Remarks

Drawings Objections

Amendments to the Drawings

The attached sheets of drawings include changes to FIGs. 6B, 7A, 7B, 7C and 8B. Sheet 5 / 20, which includes FIGs. 6A and 6B, replaces original sheet 5 / 20 including FIGs. 6A and 6B; sheet 6 / 20, which includes FIGs. 7A and 7B, replaces original sheet 6 / 20, including FIGs. 7A and 7B; sheet 7 / 20, which includes FIG. 7C, replaces original sheet 7 / 20, including FIG. 7C; sheet 8 / 20, which includes FIGs. 8A, 8B and 8C, replaces original sheet 8 / 20, which includes FIGs. 8A, 8B and 8C. In FIG. 6B previously omitted reference numerals **406** and **407** (2 instances) are added. In FIG. 7A, 7B and 7C, the lead line running from reference numeral **315** is repositioned. In FIG. 8B reference numerals **304**, **305** (2 instances) and **306** (two instances) replace erroneous instances of reference numerals **354**, **355** and **356**, respectively.

Fig. 6B

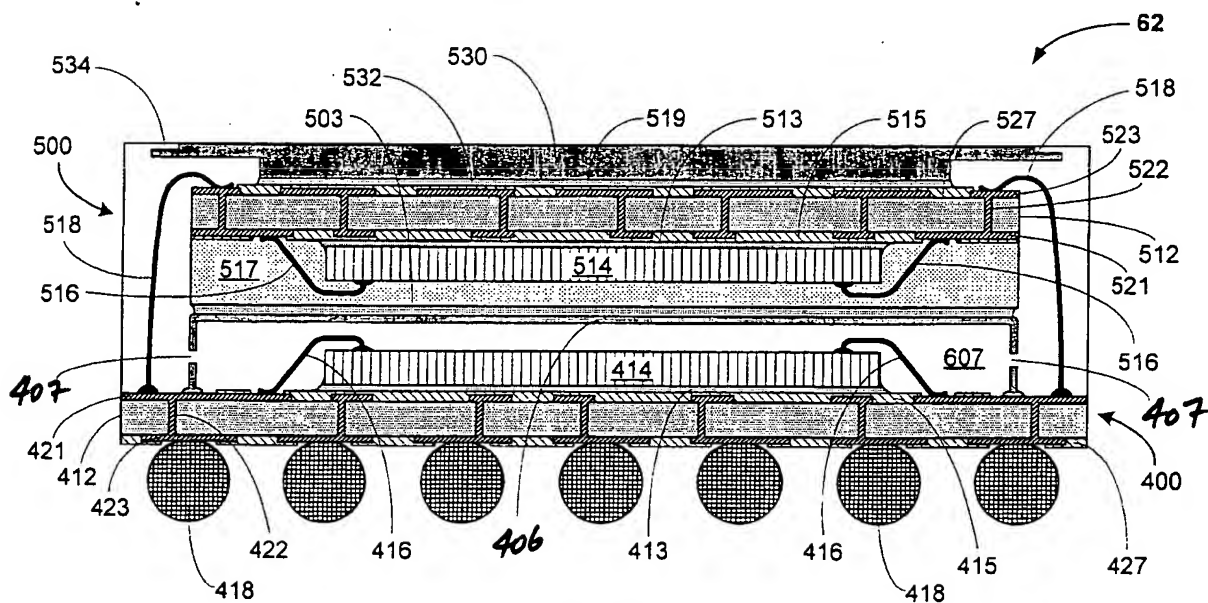
The drawings were objected to under 37 CFR 1.84(p)(5), the Examiner asserting that “they include the following reference characters not mentioned in the description: 11, 43, 47, 50, 52, 86, 90, 92, 142, 305, 306, 313, 818”, and noting further that “Fig. 6B has two lines that are not represented by references numerals.” The Examiner required correction of the drawings, or amendment of the specification.

As to the objection to Fig. **6B**, Fig. **6B** is amended herein by insertion of missing reference numeral **406**, and **407** (2 instances), to be consistent with the description and with the reference numeration of Fig. **6A**, and this objection can now be withdrawn.

Fig. 7A

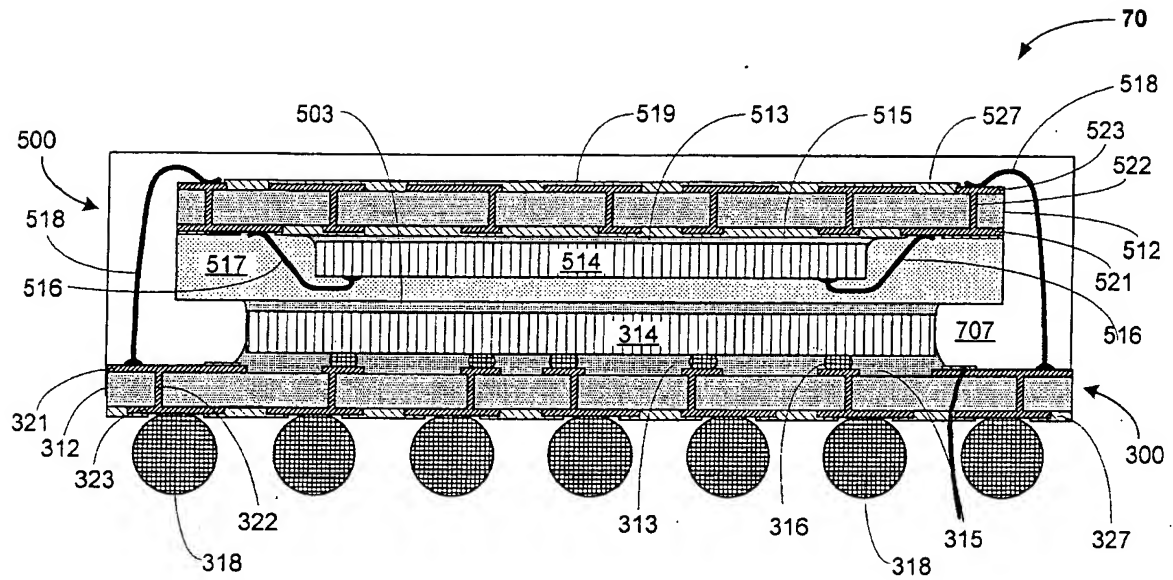
In Figs. **7A, 7B** and **7C**, the lead line from reference numeral **315** is moved, to indicate the “solder mask”, *see* paragraph **[00140]**. It is noted that reference numeral **313** indicates the underfill, *see* paragraph **[00136]**.

Fig. 8B

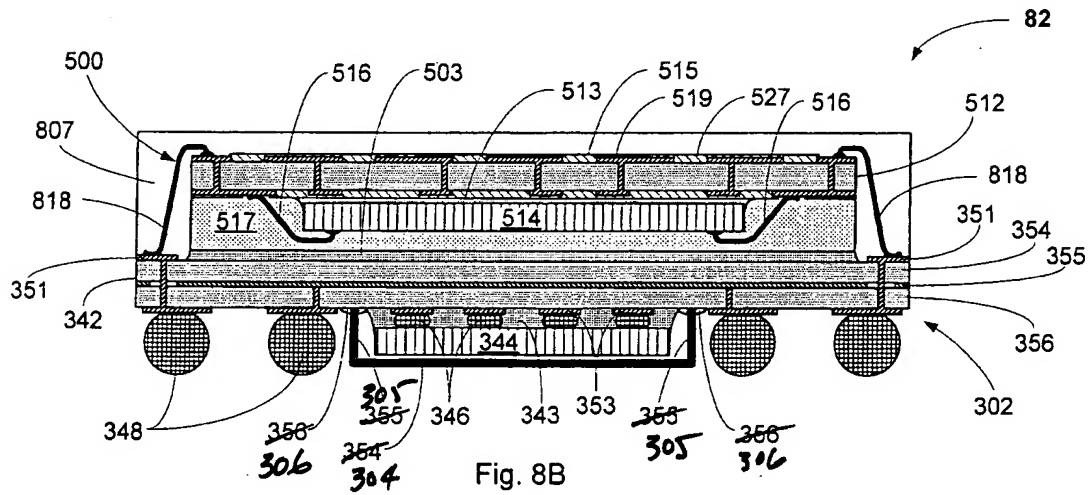
- **90, 92** -- is inserted following “embodiments of the invention” in paragraph **[00180]**;
- “**355**” is replaced with -- **305** --, “**356**” is replaced with -- **306** --, and “**354**” is replaced with -- **304** -- (paragraph **[00165]**) to make the text consistent with the reference numeration of FIG. **8C** and to avoid use of any reference numeral to identify more than one feature. It is noted that metal layer **355** is sandwiched between dielectric layers **354, 356** in bottom package substrate **342** (*see, e.g.*, paragraph **[00157]**, Figs. **8A, 8B, 8C**). Accordingly, Fig. **8B** is amended to make the reference numeration consistent with that of Fig. **8C**, by replacing the instances of reference numerals **354, 355, 356** that are directed to the lower planar part and the legs or sidewalls of the heat spreader, and the adhesive by which the heat spreader is affixed to the substrate, with, respectively, numerals **304, 305, 306**;
